QR18: PRODUCT CHANGE NOTICE

Date of Notice: (DD/MM/YYYY)	23/05/2019	Product Change Notice Number:	USB3150 B PCN 20190523
------------------------------	------------	-------------------------------	------------------------

Product Identifier:	USB3150 [includes two products USB3150-30-075-A & USB3150-30-130-A]
---------------------	---

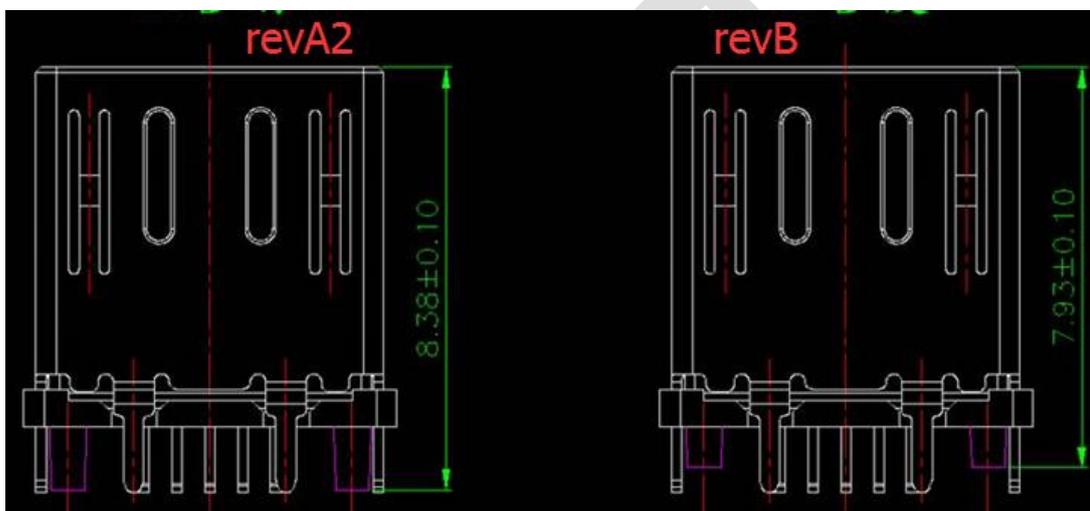
Change in height of locating peg:

Continuous Improvement / Product Resilience.

Although a change to form, it is not expected to impact PCB layout, assembly process or reliability.
